Index 102-628 Two-Way Left Turn Lane Closure

COMMENTARY

Sheet 1: Revised Detail and Notes; Deleted Conditions; Updated Symbols.

INDEX 102-628

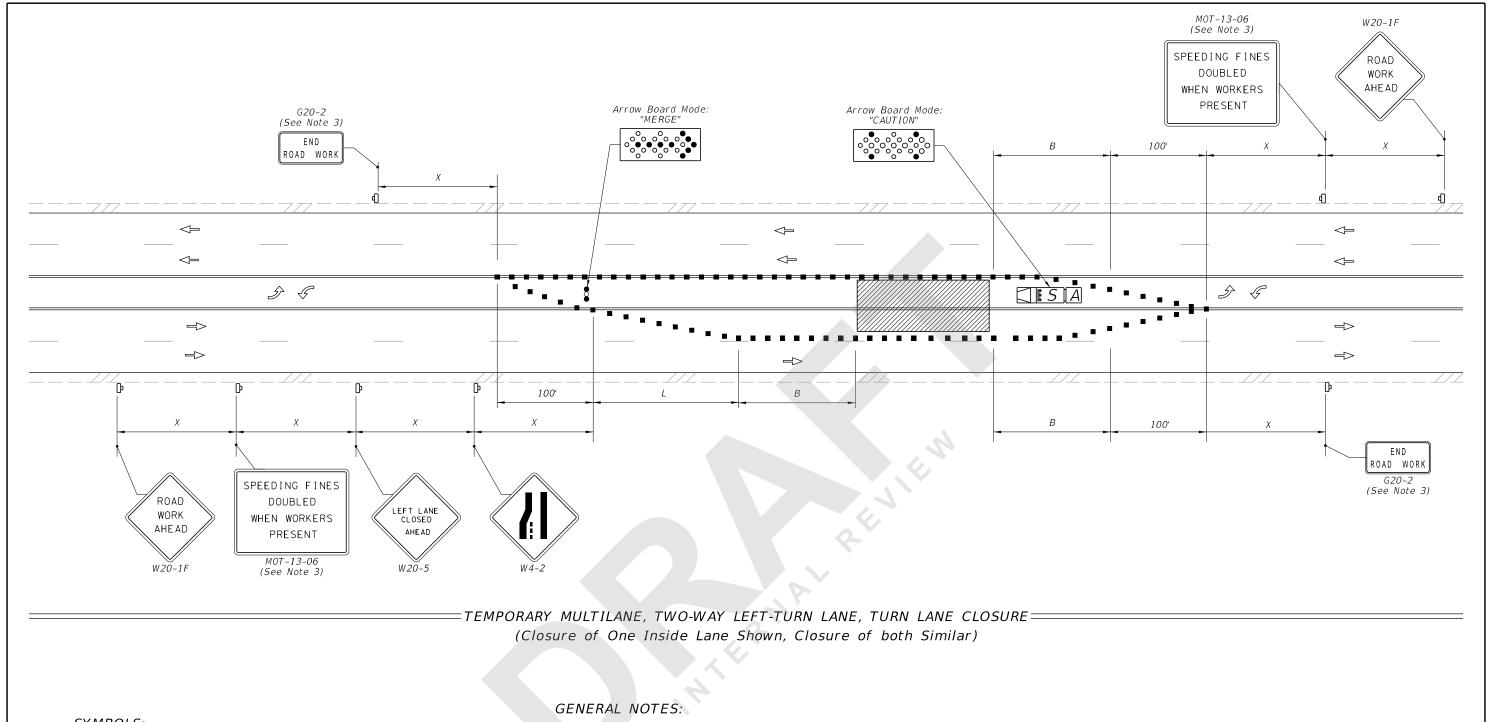
COMMENT: Don't understand why the taper and buffer and additional lane closure are different for the two sides-seems like it would be symmetrical unless the extra lane was for staging; if that is intent would denote that.

2. Is the intent to provide space for other construction vehicles to occupy and/or escape route for emergency? Or is this to provide working space for the contractor from the travel? If for the latter option, why only one side?

Consideration for additional arrow board on right side of detail in Caution mode (similar to shoulder closure in TA-4) in current detail

RESPONSE: The detail is not symmetrical because there is only a Merging Taper on one side. However, it is noted that the buffer space (B) is not proportionally shown.

Change Made: Corrected proportionality of "B" dimensions.

RESPONSE: The intent was to provide a more practical and conservative approach to the closure of two way left turn lane on multilane roadways. Consideration will be given to providing an expanded work area accommodation that closes both inside lanes. **Change Pending**

RESPONSE: Agreed.

Change Made: Added TMA and Shadow Vehicle (S) with arrow board in "Caution" mode.

= TEMPORARY TWO-WAY LEFT-TURN LANE CLOSURE, TWO-LANE, TWO-WAY ROADWAY, WORK WITHIN THE =TRAVELED WAY WITH LANE CLOSURES OF 24 HRS OR LESS AND WORK ZONE SPEED OF 45 MPH OR LESS

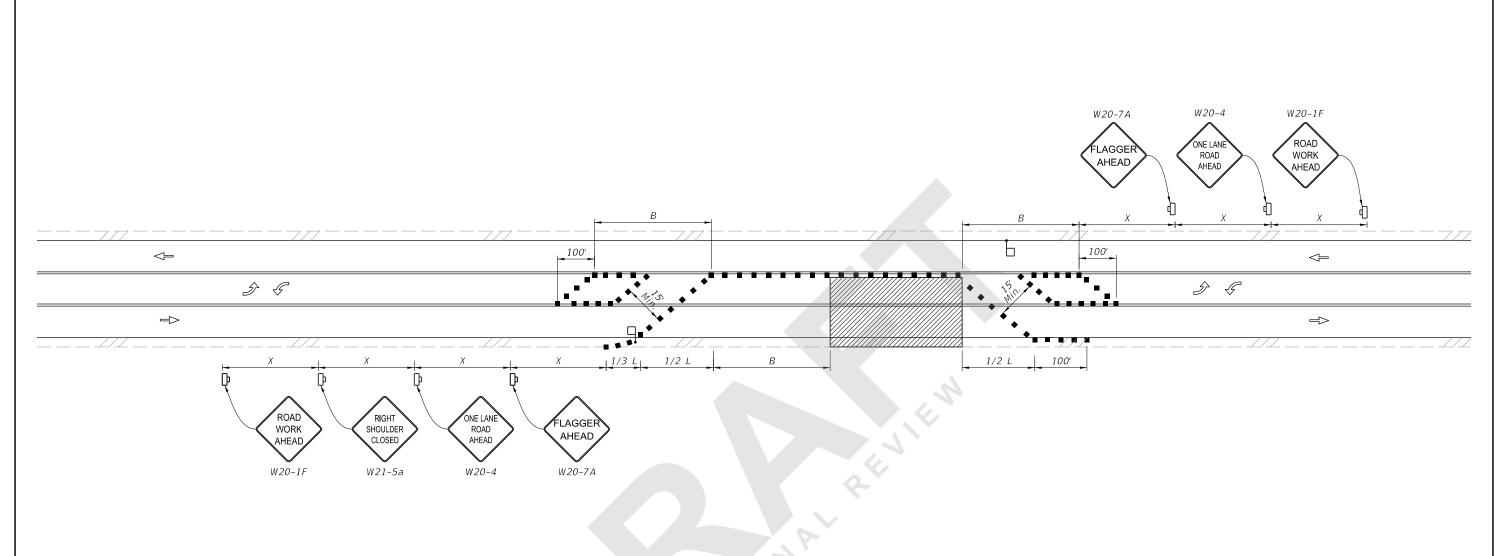
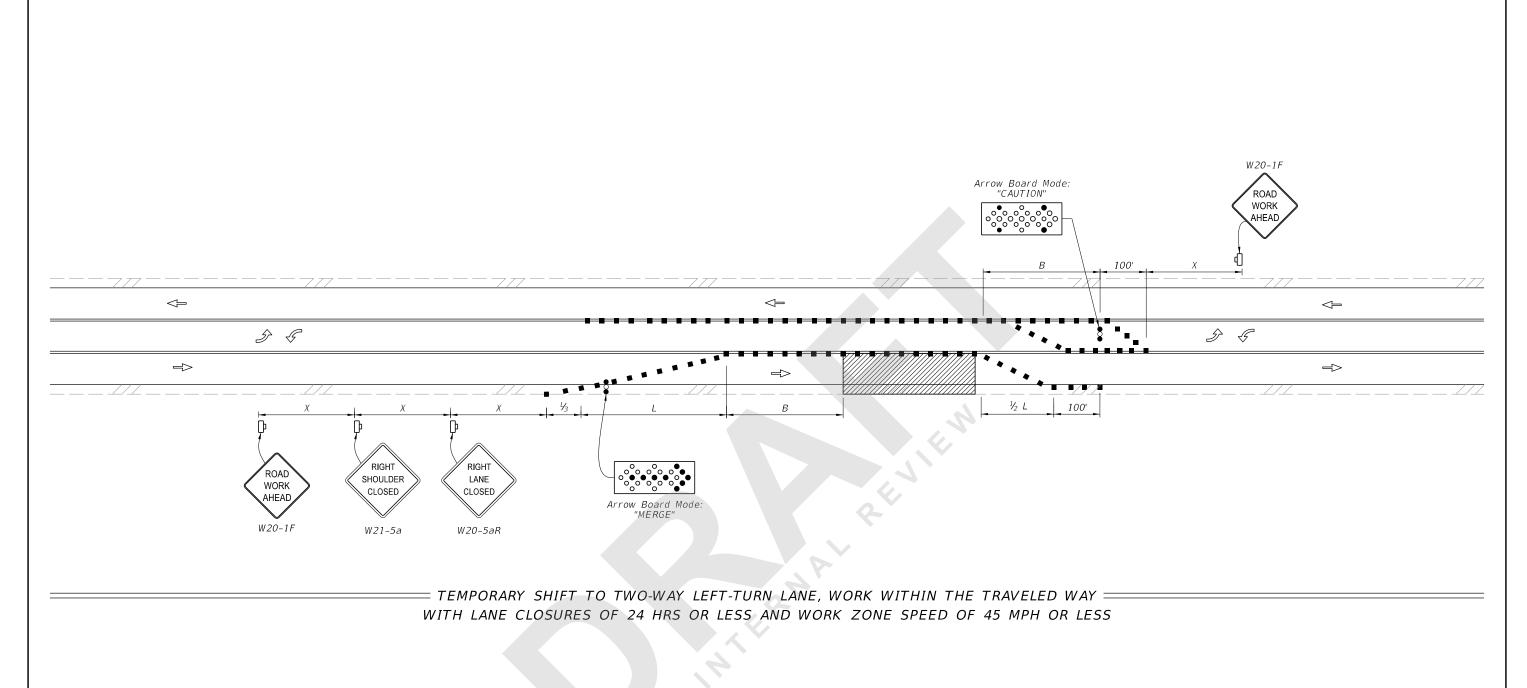
COMMENT: This will not work on a road with one lane in each direction. What index will be

used in that scenario?

1. This index only addresses multi-lane facilities with bi-directional left turn lane. This would not work for 3-lane sections. Either another detail or additional notes should be provided (even though it's common sense application)

RESPONSE: Agreed. The standard application was modified to provide a more practical and conservative approach to the closure of two way left turn lane on multilane roadways.

Change Made: Two new standards applications have been added for 3-Lane roadways. One for the closure of a travel lane (w/traffic shifted into the turn-lane) and the other for the closure of the turn-lane and one travel lane (i.e., flagger controlled similar to Two Lane, Two Way Work within the Traveled Way).

RESPONSE: Agreed. Additional details are being developed for a 3-Lane section. Change Made: Two new standards applications have been added for 3-Lane roadways. One for the closure of a travel lane (w/traffic shifted into the turn-lane) and the other for the closure of the turn-lane and one travel lane (i.e., flagger controlled similar to Two Lane, Two Way Work within the Traveled Way).
